Texas Commission on Environmental Quality

Facility Name: Fort Bend Regional Landfill LP

**RE: Permit Application for New Industrial Non-Hazardous Solid Waste Permit for the
Fort Bend Regional Landfill, LP (Proposed Permit No. 96322)
RN102803913 / CN602656373
Response to Technical Notice of Deficiency Tracking No. 29597016**

**Attachment 1 – Comment Response
Summary Table**

**Attachments – Response to T7:
Attachment IV.D.1 – Site Map**

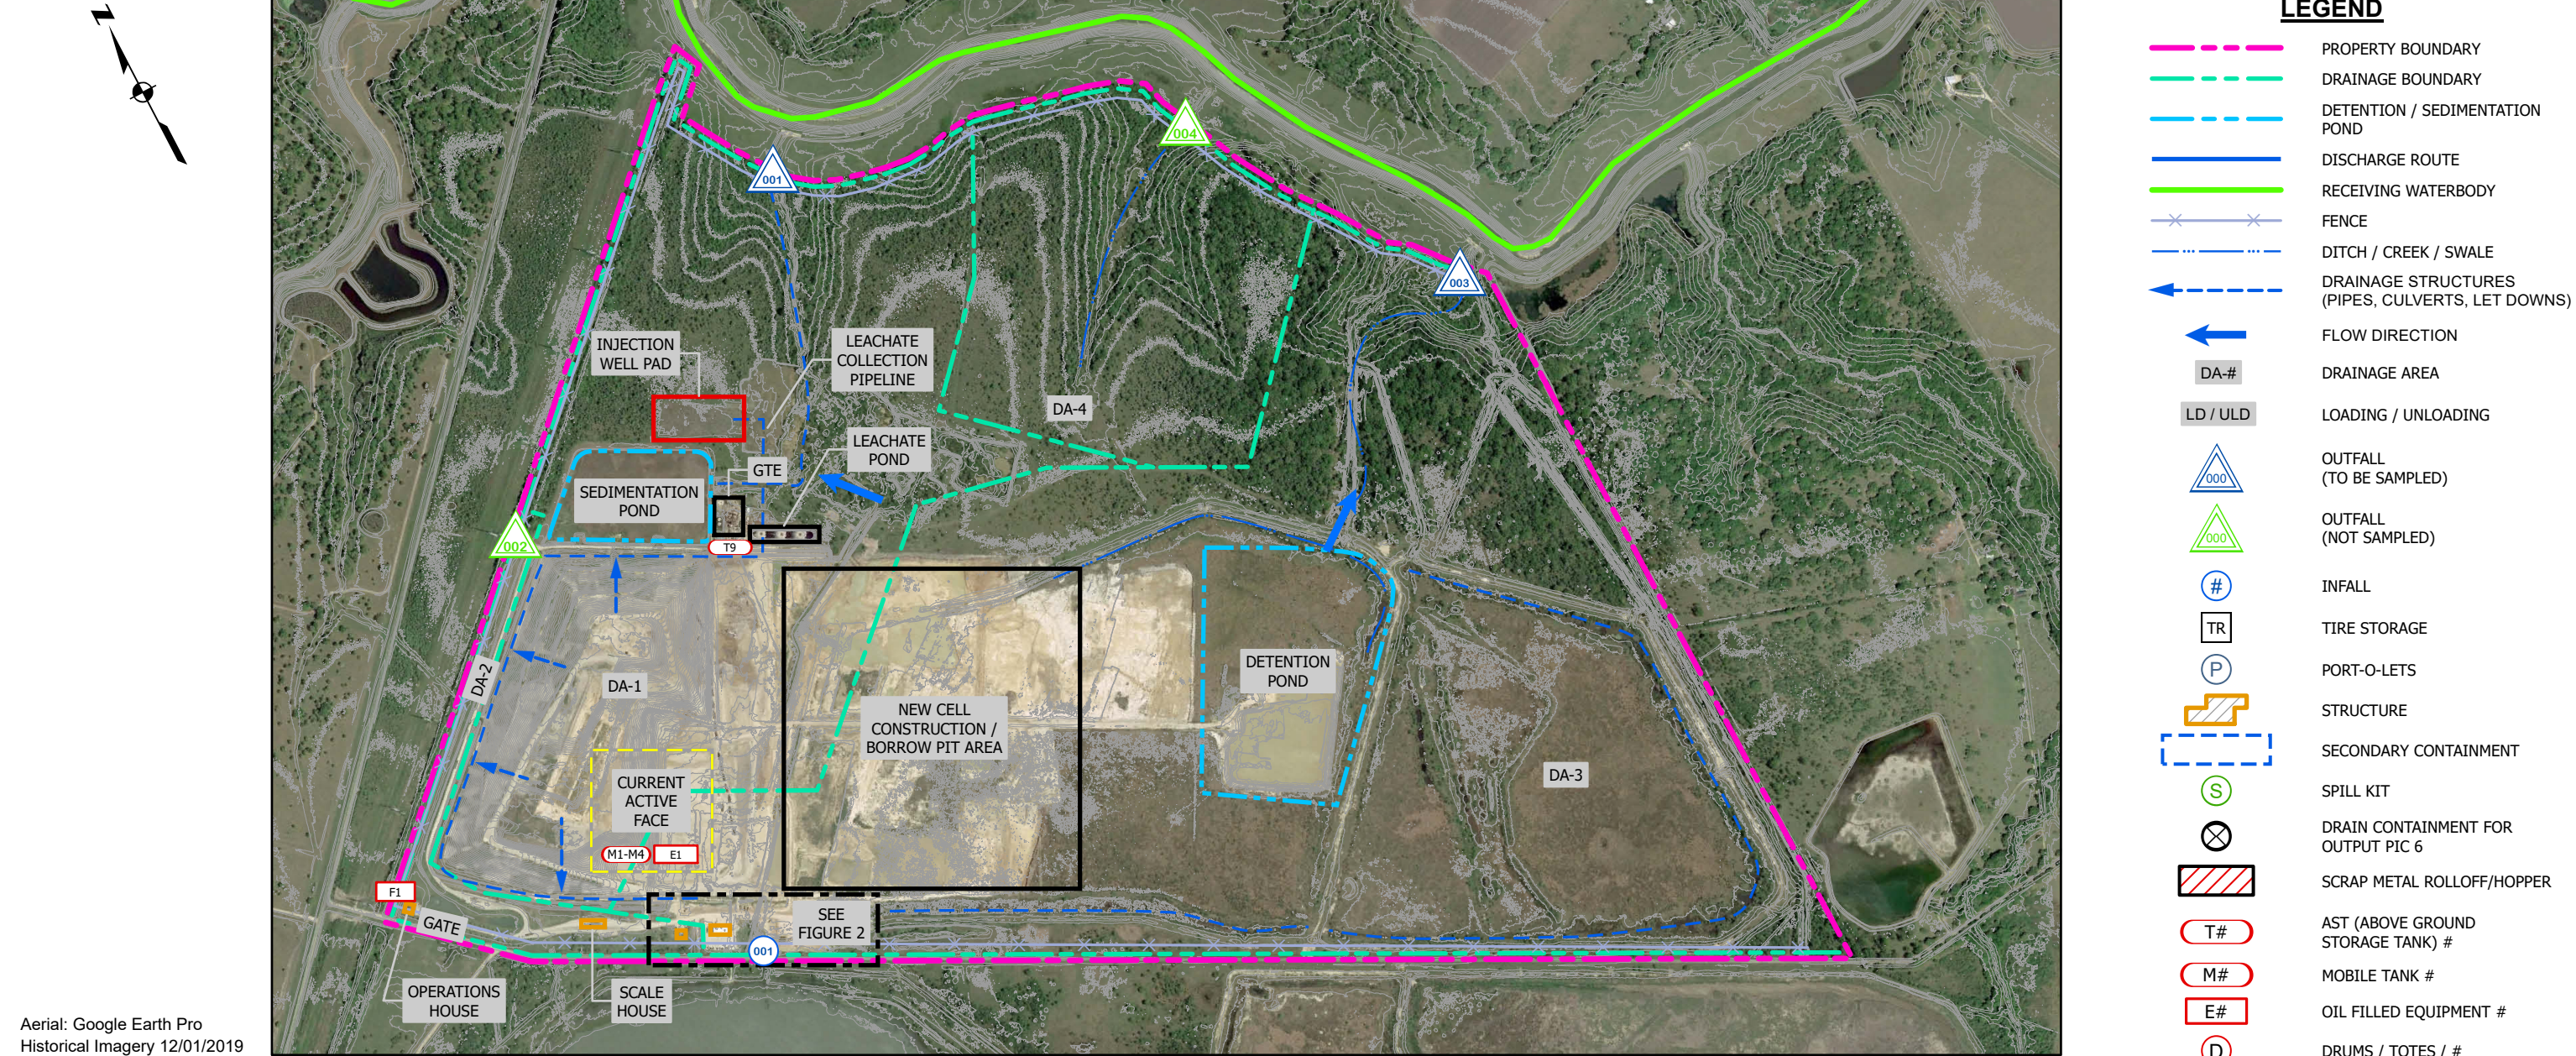
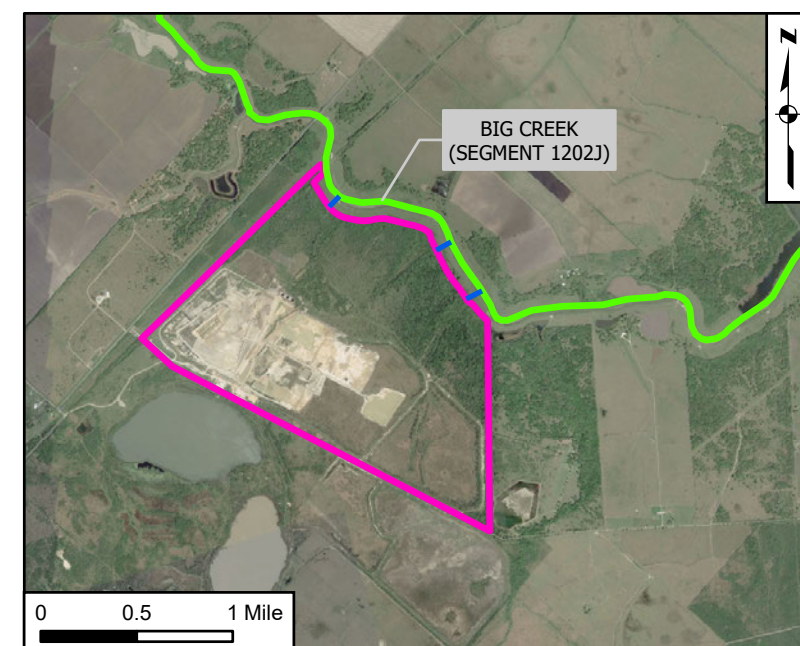
T6	n/a	IV	Attachment IV.B.2	305.45(a)(8)(C)	Incorrect	Correct the dates in the figures named, "Legend and Symbols (2 pages) and "Process Flow Diagram (first page)". These figures have the wrong date of 12/08/24 at the bottom of the page.	The issue dates in Attachment IV.B.2 have been corrected in the attached replacement.
T7	n/a	IV	Attachment IV.D.1	305.45(a)(8)(C)	Incomplete	Show contour intervals on the site map at a scale no less than 1in. = 200 ft and show the location of the leachate line to the UIC Waste Management area.	The replacement Attachment IV.D.1 includes contours at an interval of 2-ft and the location of the leachate line. Note that a smaller scale is used due to the size of the facility, whereas a scale of 1 inch = 200 ft would require breaking up the map into multiple maps.
T8	n/a	VI	Attachment VI.A	305.45(a)(8)(C)	Incomplete	Revise the figure named Leachate Force Main Routing to show the UIC Waste Management area.	The replacement Attachment VI.A includes an annotation showing the area of the UIC Well Pad and Pre-Injection Area.

**Attachments – Response to T8:
Attachment VI.A – Groundwater
Monitoring System**

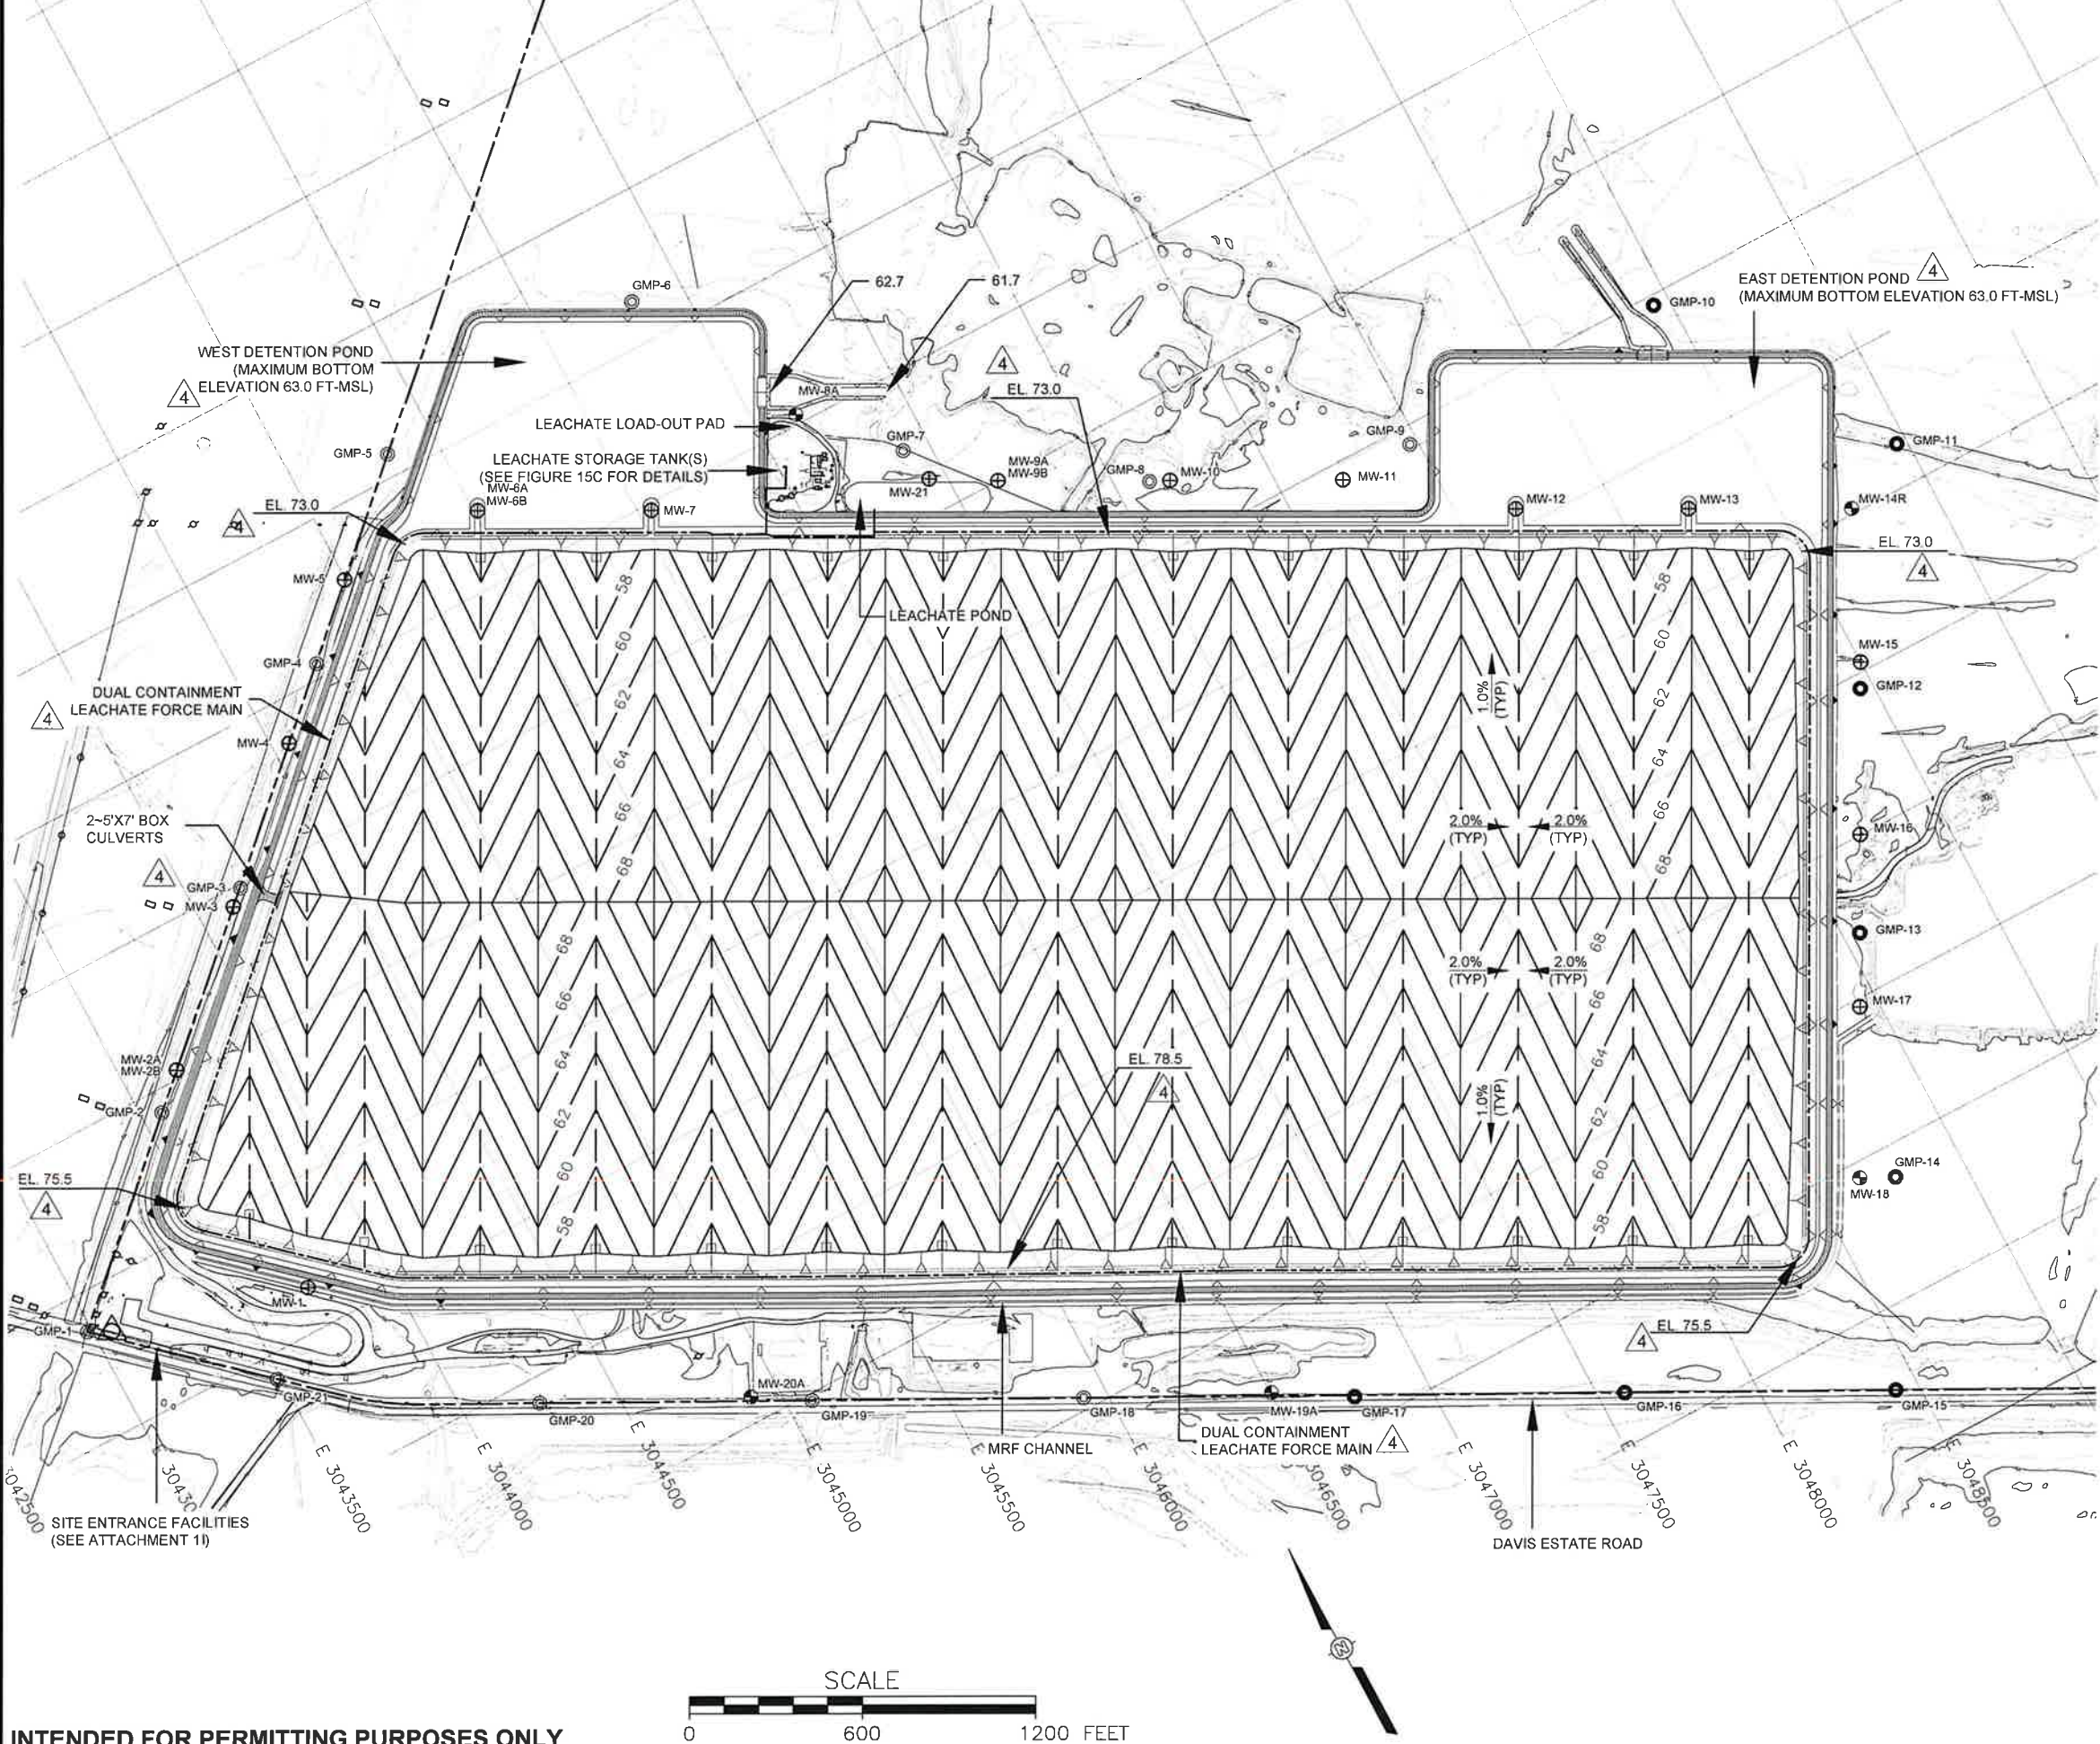
ID ¹	App	App. Section	Location ²	Citation	Error Type ³	TCEQ Deficiency Description/Resolution	Response
T9	n/a	VII		37.31(a)	Reminder	Submit an originally signed financial assurance mechanism to the executive director 60 days prior to acceptance of waste. The mechanism must be in effect before the initial receipt of waste.	Fort Bend Regional Landfill, LP recognizes that financial assurance needs to be in-place prior to accepting wastes. Note that the application text for Section VII.A.5 was revised to reflect this.
